6888 Ch-ch EQ CBD Building Performance Investigation

Hotel Grand Chancellor - Final 26 Sept 2011

Questions on “Report on Structural Performance of Hotel Grand Chancellor”

Fig. 6(a)

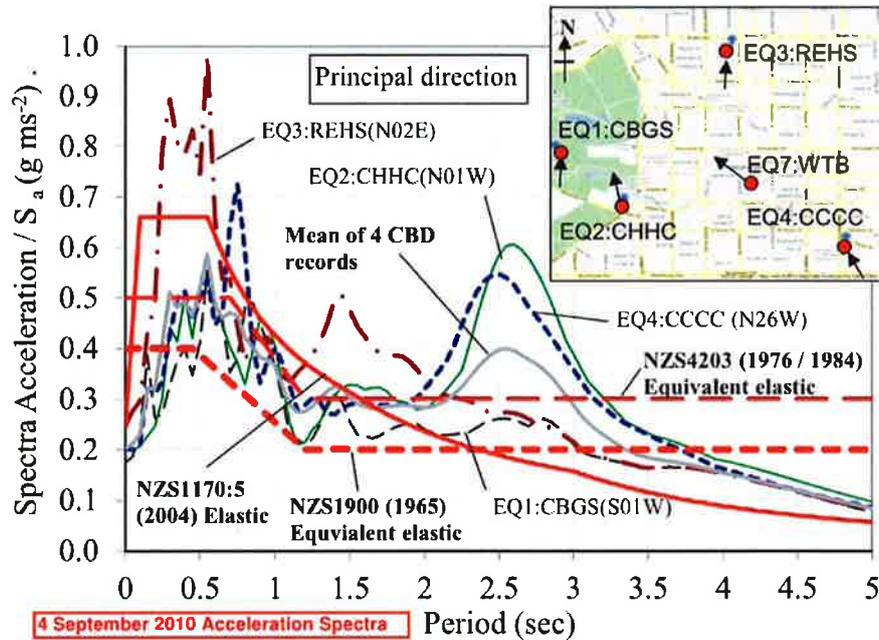
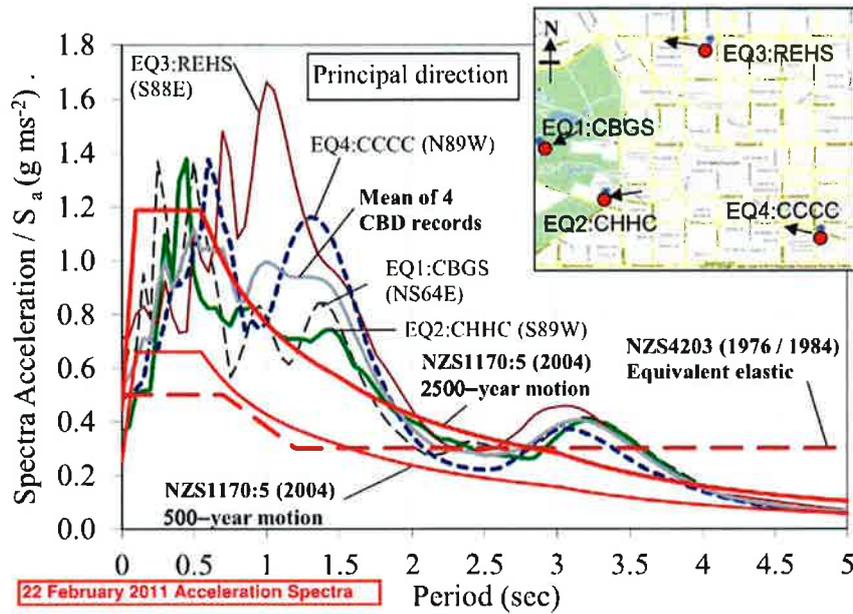
1. On pages 13 and 14 in Figure 6 parts (a) and (c) of the report the spectral accelerations are shown for the September and February earthquakes together with the design spectral accelerations given in the design standards, NZS1900: 1965, NZS4203: 1976 and 1984 and NZS1170.5: 2004. In the design standards of 1965, 1976 and 1984 the spectral accelerations are shown as constant for periods between 1.4 and 5 seconds. In Figure 6, parts (b) and (d) the corresponding spectral displacements are shown as constant over the range of 3 to 5 seconds. Is this logical and is it consistent with the clauses in the relevant standards?

Fig. 6(b)

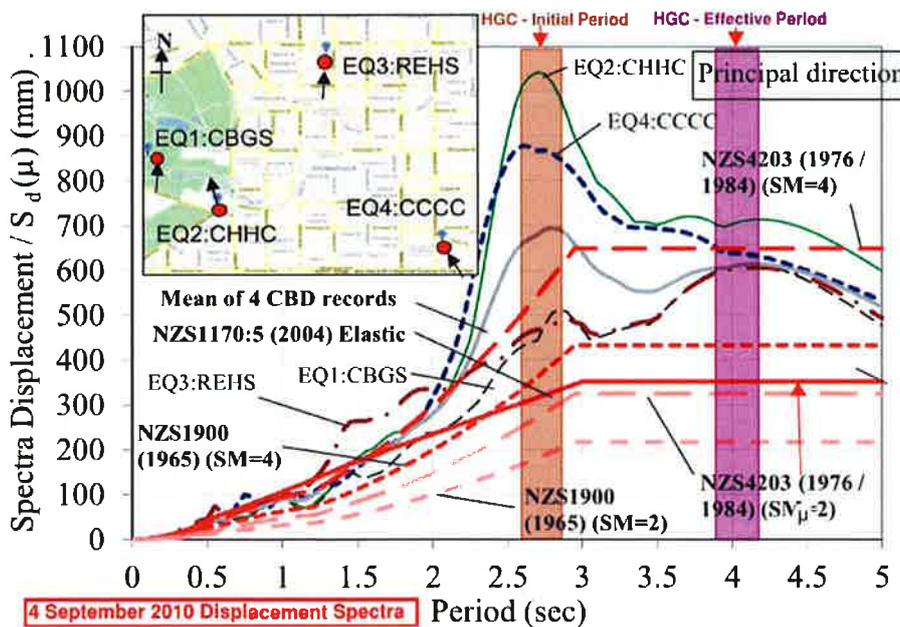
- What other factors would you require before it is possible to predict that the wall would fail or survive the assessed axial load?
- 8 On page 29 in the last bullet point it is indicated that a factor contributing to vulnerability of the wall was “Code defined actions exceeded by the February Earthquake”. The axial load was determined by capacity design and the displacement response spectra for structures with a displacement ductility of between 2 and 4 is of the order of 400-500mm (see Carr report and question 4) and the design spectral displacement is a little under 600mm (see figure 6 (b) in the report). What code actions are you referring to and in which code?

Fig.7

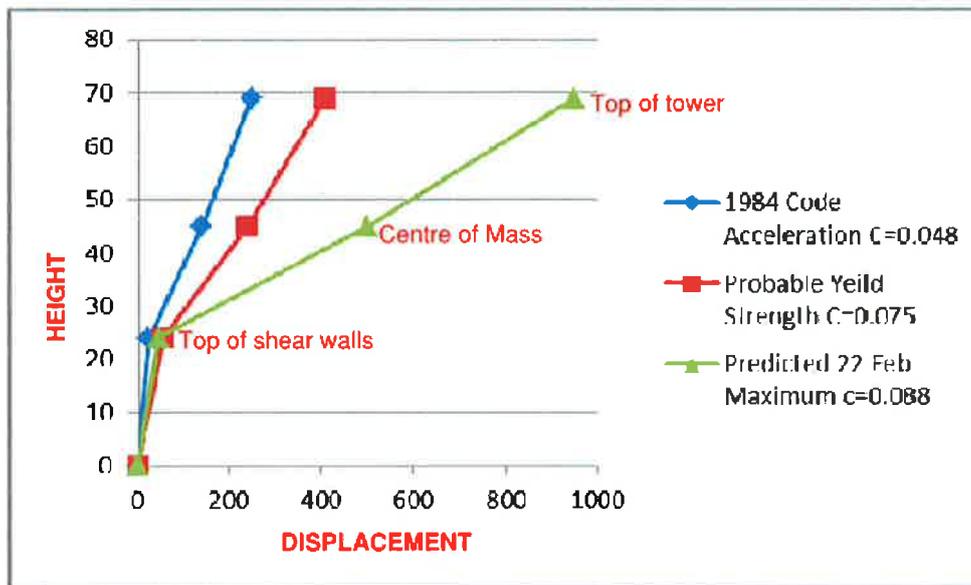
2. On page 17 Figure 7 there is reference to the “Centre of mass”. Can you please define what is meant by this term?
3. On page 15 of the report in the first bullet point it is indicated that; in September the maximum possible displacement was 700mm (average) while in February it was 1050mm (average) displacement.

Sketch 2

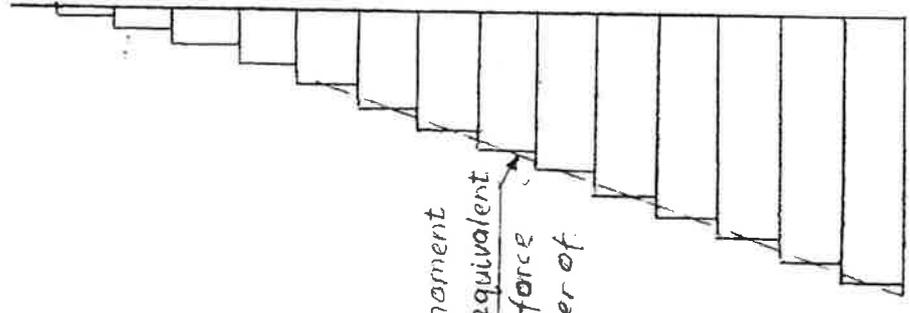
- 13 The top $\frac{3}{4}$ of the building (HGC) consists of a tower in which the lateral force resistance is provided by moment resisting frames. A portion of the floor on the East side of the building is cantilevered out from the moment resisting frames, see Sketch 2. This cantilever action induces bending moments into the structure as a whole as illustrated in sketch 3.

- How would this cantilever action influence the behaviour of the building in a major earthquake?
 - What would be the likely significance of the cantilever actions for the behaviour of the building in the 22nd February earthquake of 2011?

- Do you agree this would cause the building to ratchet towards the East?
 - Does your analysis make any allowance for this ratcheting action and if so how much?
